MEMORANDUM

RE: O'Reilly Auto Parts – Signage Variance – Project No. 8698

Staff's Summary and Recommendations

1 NORTH ELEVATION
A2.1 SCALE: 1/8" = 1'-0"

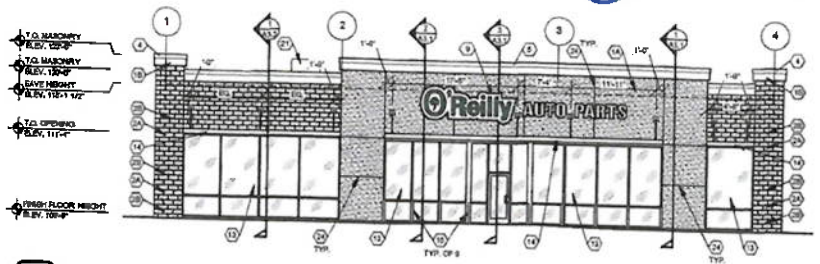
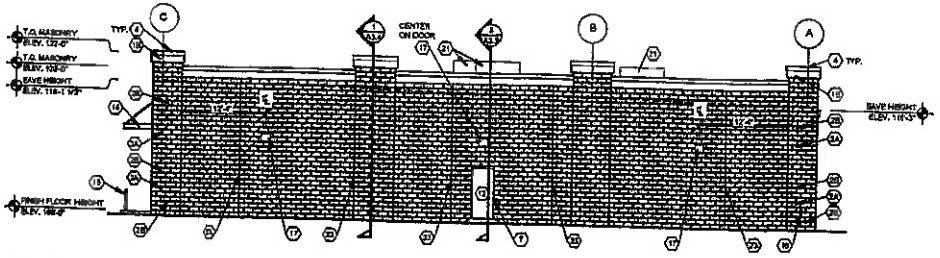
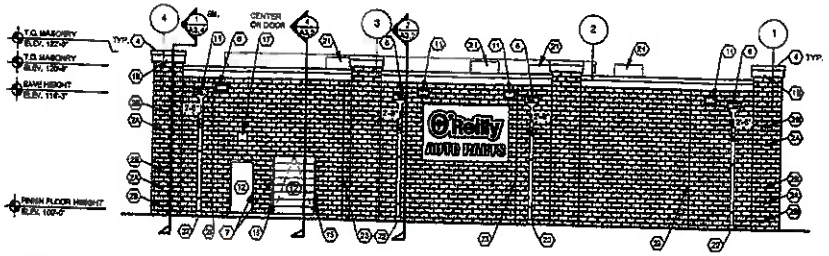
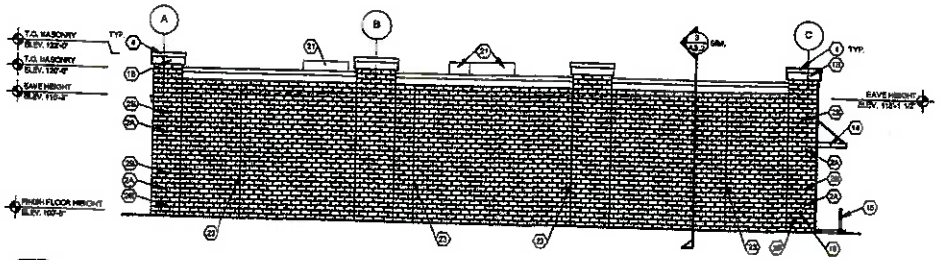
- Maximum Wall Sign Height (under 10,000 sq. ft.; building is 7,908 sq. ft.): 1½ in. per foot of wall height
- Building Wall Height: 22'-0" (sheets G1.1 and A5.2); maximum sign height: **33 inches**
- The requested 63-inch sign exceeds the maximum by 30 inches, approximately a 91% increase over permitted height.
- The stated hardship (building setback and parking area in front of the store) is typical of commercial pad sites along Meridiana Parkway.

Based on the variance criteria in Sec. 30-36 the wall sign standards in Section 25 of the Sign Ordinance (Ordinance No. 2016-19, as amended), staff recommends denial of the request for a 63-inch wall sign due to:

- Lack of demonstrated unique hardship; the claimed condition is consistent with the all commercial development along Meridiana Parkway.
- The requested sign height is a 91% increase over permitted height. This is a significant deviation from the wall sign height standard in Section 25 of the Sign Ordinance.
